### Request for Review

"7.2 MW Wind Project at Chitradurga, Karnataka" (1341)

Please find below the response of the project participant and the TÜV NORD JI/CDM Certification Program to the requests for review (dt. 23/11/2007, 25/11/2007 and 28/11/2007) for the above mentioned project no. 1341.

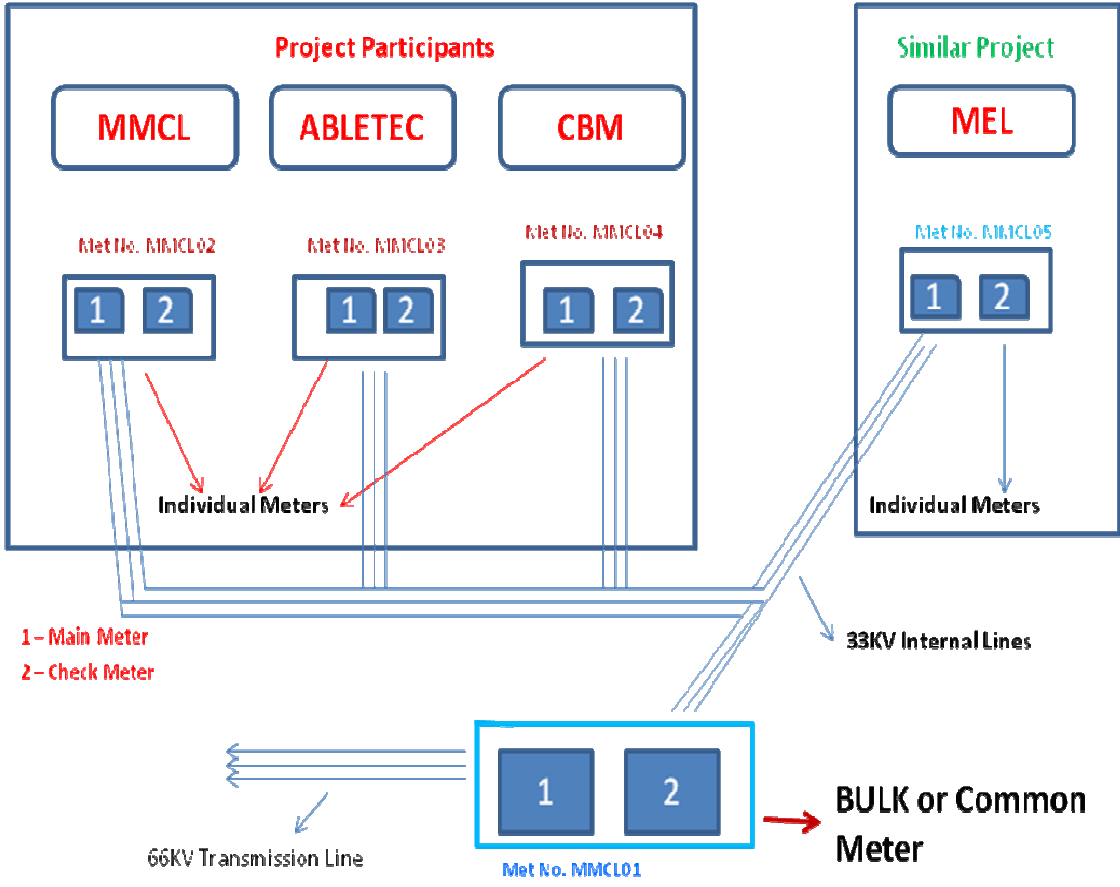
Issue raised by EB Member(s) / DNA	<p><i>"The monitoring plan is as per the methodology. However as there are similar wind energy projects in the region (and in some situations, with same project proponents/suppliers) there is a probability of more than one project supplying to the same sub-station. The PP shall further clarify whether this is the case. In addition the DOE shall further clarify how they have addressed the risk of double counting and which systems are in place to avoid double counting."</i></p> <p><i>(Refer comment no. 3 of Request for Review dt.23/11/2007)</i></p>
------------------------------------	--

Response of project participant	<p>Yes, there is one more co-investor having 3 number of WTG, each of 800 KW, totaling 2.40MW capacity, who is also supplying to the same sub-station and the said investor has not opted for CDM benefits with the PPs.</p> <p>Following foolproof methodology is adopted to avoid double counting of generation:</p> <ol style="list-style-type: none"> <li>Individual meters are established so as to measure generation by individual project. The generated power is stepped up to 33 KV by using step-up transformer, metered by individual meters and transferred to sub-station via internal 33 KVA lines to the 12.50 MVA transformer installed at the substation at the bottom of the hill. From the substation, the power is further stepped up to 66 KVA and generation will be measured at the bulk meter (common meter) (common meter - combined for all the projects) and then fed into KPTCL Grid via 66 KVA overhead lines.</li> </ol> <p>More over, in order to attain 100% accuracy &amp; to perform cross check, along with main meter, Check meter is also installed at both individual and bulk meter.</p> <ol style="list-style-type: none"> <li>Both the meters i.e. individual meters and bulk meters are properly sealed and monitored by KPTCL and Bangalore Electricity Supply Company (BESCOM) Officials.</li> <li>Metering Procedure: At the close of each month, joint meter reading will be done by BESCOM and KPTCL officials in presence of PP for both individual and bulk meters. The readings of both these meters are taken and transmission loss between individual meter and Bulk meter will be shared proportionately for billing purpose.</li> </ol> <p>The Above procedure is explained with live data for the month of November, 2007: (Refer Evidence Annex 1)</p> <p><b>A. INDIVIDUAL METERING POINT:</b></p> <p>Metering Point:- Individual Project on top of the Hill (Technically called as 33KV Metering Point)</p>

From the above explanation, it is evident that foolproof system is in place by having individual meters and the generated power in KWH is counted based on the individual meter reading after deducting transmission loss from individual meter to bulk meter for each project. Thus the risk of double counting is permanently avoided.

**The above procedure is more clearly explained in the following pictorial representation:**

<p>Response of DOE</p>	<p>There is foolproof system available to avoid the risk of double counting. As described above in the pictorial form, the power generated from each WTG is metered through the main meter and check meter with unique identification allocated to each project participant. Further to understand this case, let us take the example of project participant MMCL. MMCL has installed 6 WTG, each of 800 KW, with total capacity of 4.2 MW. Now the power generated through these 6 WTG is metered through Meter No. MMCL 02, having main meter and check meter. The power metered through main meter is further stepped up &amp; is metered through bulk (common meter) having main &amp; check meter. Further considering the same example, power exported for the month of Nov, 2007 by MMCL, meter reading at MMCL 02 meter: 501300 KWH (Reading through the MMCL 02 meter reading) – 5381 KWH (Transmission loss i.e. 1.073% , accounted through total bulk meter reading and subtracting the proportionate transmission loss ) = 495919 KWH. Thus the system described above is able to give the actual power exported by the individual project participant without any ambiguity and double counting. Further, it is also verified that individual meters and bulk meters are properly sealed and monitored by KPTCL and BESCOM officials. (Documentary evidence is attached in folder <i>Comment 3</i>)</p>
